MEETING

| Meeting Date | 19/10/2010 | Ref | TEC-EDP/DJ/2010/MoM/03 |

| Subject | SpW WG meeting #15 - Session 3: SpaceWire evolutions and standard revision | Copy |

Figure 1 - Generic example of SpaceWire network

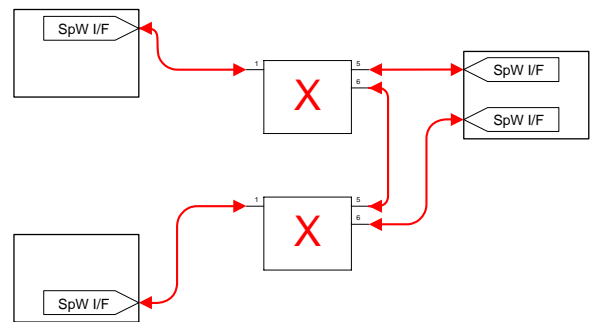
Many SpaceWire users have identified some ambiguity in the definition of node. Considering the generic example of SpaceWire network shown in Figure 1, the recurring questions are the following ones:

- Is a SpaceWire node  /  ?
- Or is it  ?

In the telecom/computer networks terminology,  is a “terminal” (terminals and routers/switches are “nodes” of the network, as opposed to “links” of the network) while  is not defined since it is not part of the protocol stack.

Clarify the definition of nodes

- How to clarify it is still an open point
